Access Compliance Report

Public Rights-of-Way

(Pedestrian Signals)

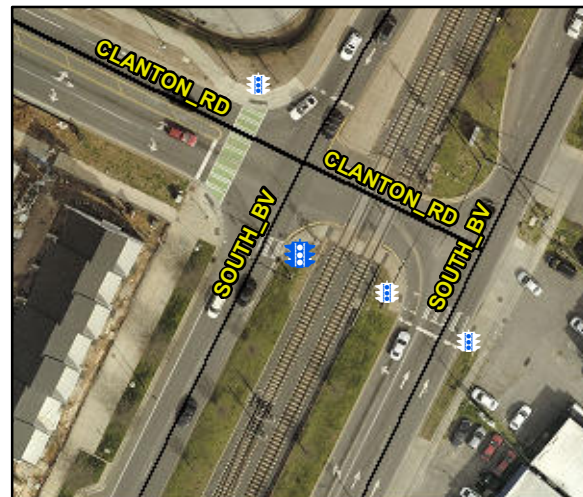
Intersection ID: N/A	Main Street:	Cross Street: N/A	Location: N/A
ADA ID: 9DC216DEA7F9	Signal Type: One Push Button-APS	Overall Compliance: No	Severity Score: BTN 1: N/A BTN 2: N/A No BTN: N/A
Codes/Mitigation Info/Possible Solution		Field Measurements/Component Compliance

Surveyor Notes: N/A

Possible Solutions: Replace Signal Push Button With APS Button on New Post. Remove & Relocate Sign.
